**AGENDA**  
**PLANNING COMMISSION**  
**COUNCIL BLUFFS PUBLIC LIBRARY,**  
**400 WILLOW AVENUE, COUNCIL BLUFFS, IA**  
**Tuesday, June 10, 2025 - 6:00 PM**

Case/Project No.: PC-25-002

**Request:** Public hearing on the request of Huegerich Construction Inc. to adopt a P-C/Planned Commercial development plan for a 124-unit extended stay hotel on property legally described as Lot 1, Morris Subdivision, Replat 1, City of Council Bluffs, Pottawattamie County, Iowa.

Combined public hearings on the request of Arbor Creek, LLC, represented by Neal Drickey, for preliminary plan approval of a 17-lot residential subdivision to be known as Arbor Creek 2nd Addition, legally described as Lot 2, Arbor Creek, and to amend the adopted PR/Planned Residential development plan for said property to allow construction of 16 attached single-family residential dwellings. Location: Undeveloped land lying south of 1020 Railroad Avenue.

Zoning Compliance Plan

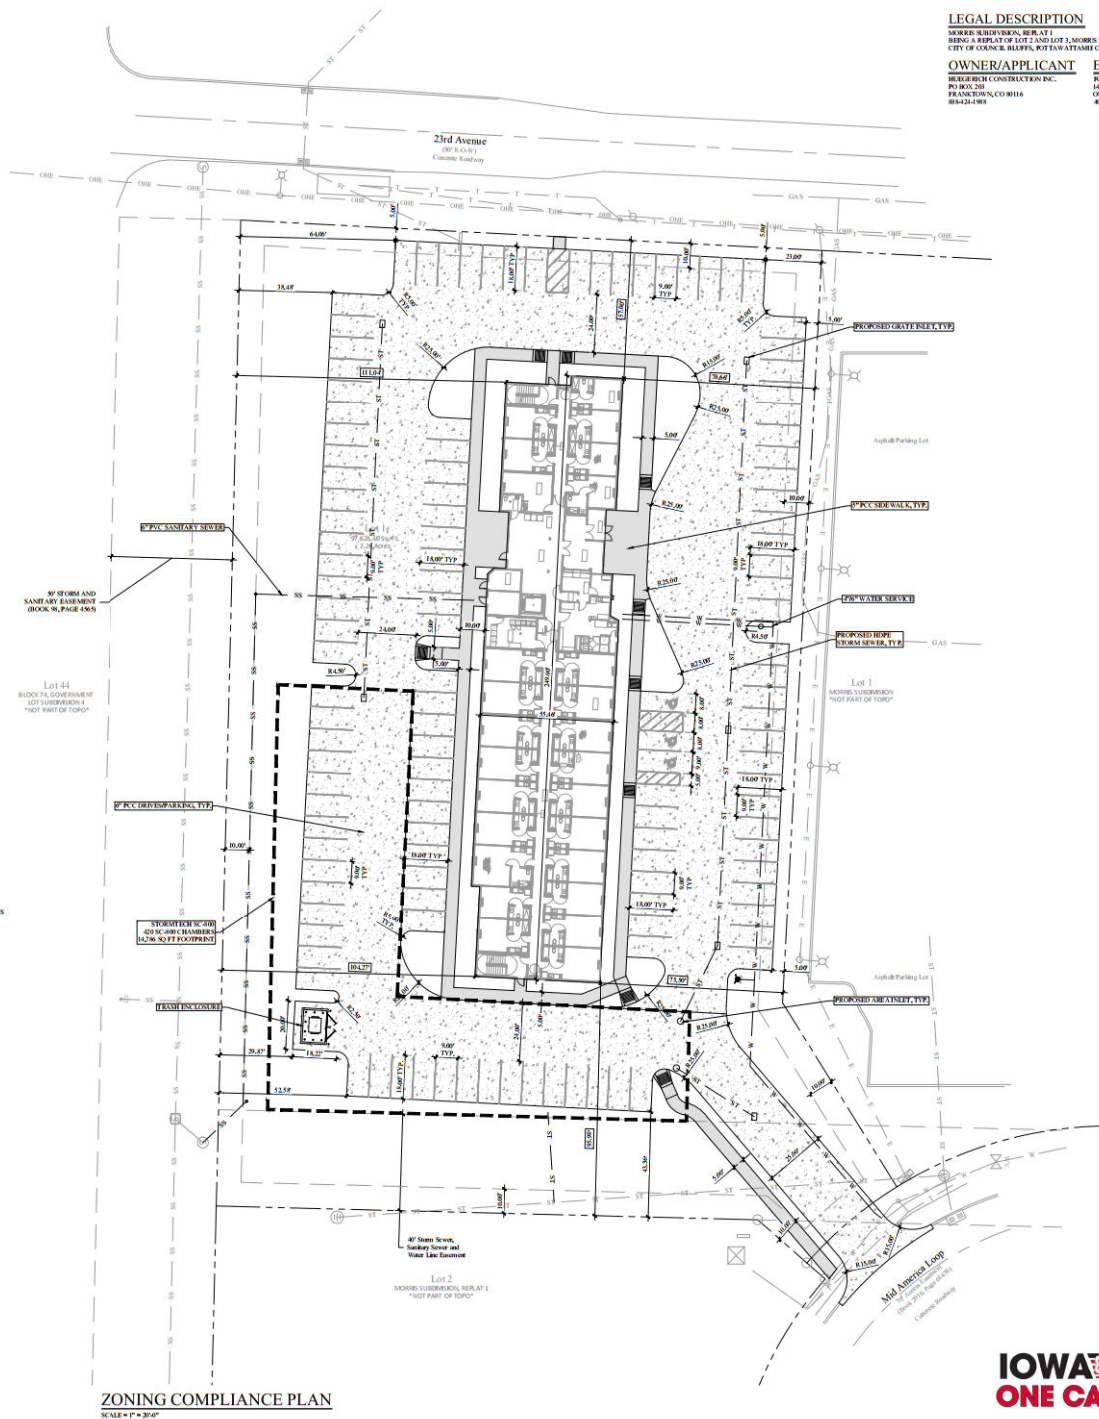
6. The submitted site plan, included as Attachment 'C', shows an enclosed dumpster in the southwest corner of the parking lot. Per the submitted plans, the dumpster enclosure will be eight (8) feet tall wall comprised of split face concrete masonry unit (CMU) with a metal gate. Said dumpster and any trash receptacles and/or dumpsters visible from a public right-of-way shall be enclosed on three sides with a masonry, wood, or vinyl fence and have a lockable gate that when closed completely eliminates view of the dumpster. Any walls or fencing installed to enclose a trash receptacle/dumpster shall be allowed to extend no more than six inches from the peak of the trash receptacle/dumpster it is screening.

- a. A detailed photometric plan showing the location and type of light fixtures shall be submitted at +the time of permit review.
9. The submitted site plan, included as Attachment 'C', shows a sidewalk along the westerly side of the entrance drive off Mid America Loop and a sidewalk stubbed out to the northerly property line to facilitate future sidewalk connections in this area. All sidewalks shown on the proposed site plan shall be installed prior to issuance of a Certificate of Occupancy for the hotel.

2. The Americans with Disabilities Act (ADA) requires a minimum of five (5) accessible parking spaces for parking lots containing 101 to 150 off-street parking stalls. The submitted plans show a total of 124

stalls but only three (3) accessible parking spaces. The parking lot plan submitted at the time of permit applications shall be revised to meet the minimum five (5) accessible spaces required. All off-street parking lots shall comply with Chapter 661-18, Parking for Persons with Disabilities, of the Iowa Administrative Code.

## EXTERIOR ELEVATIONS

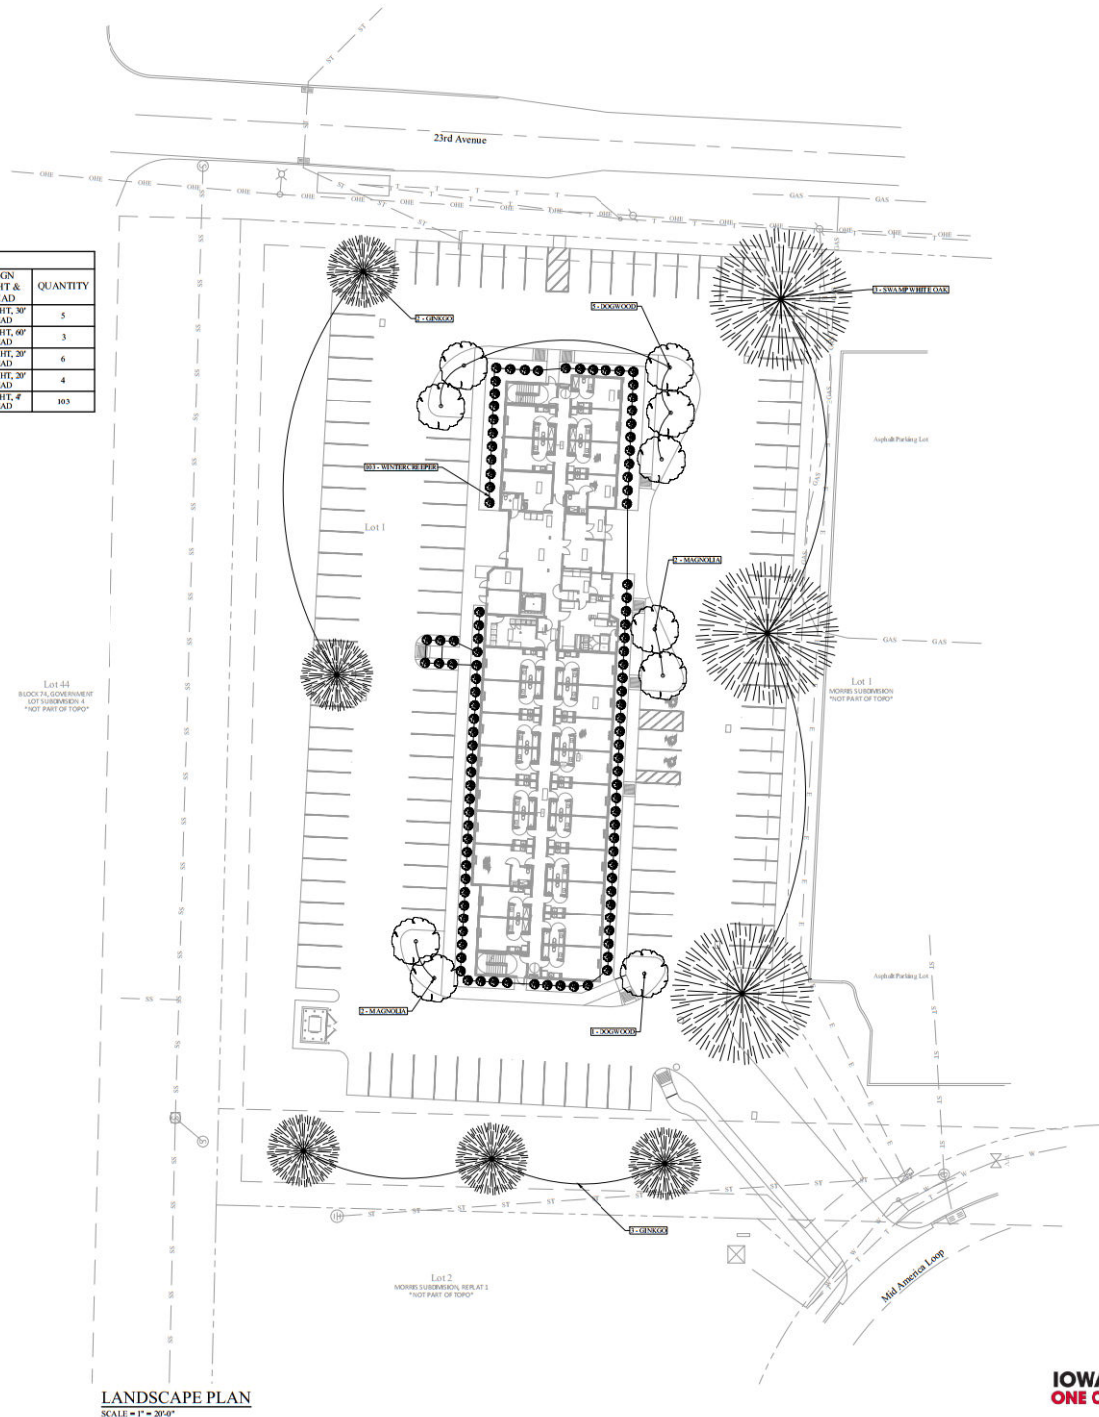
1. Architectural renderings/building elevations for the proposed hotel are shown in Attachment 'D.' The building exterior is primarily made up of EIFS, with a brick veneer base on the south, east, and west facades. The north façade partially utilizes a brick base with a vertical green EIFS accent breaking up said base. The facades utilize four different colors of EIFS to help provide visual interest and horizontal and vertical breaks. The Community Development Department recommends the proposed architectural renderings be accepted as proposed.

1. The submitted architectural elevations, included as Attachment 'D', show the following signage:

<b><u>Facade</u></b>	<b><u>Attached Wall Signage</u></b>	<b><u>Approximate Size (Sq. Ft.)</u></b>
North	"Echo Suites"	68
East	Extended Stay by Wyndham"	15
West	"Echo Suites"	83
	"Extended Stay by Wyndham"	15
	"Extended Stay by Wyndham"	12
<i>Total:</i>		<i>193</i>
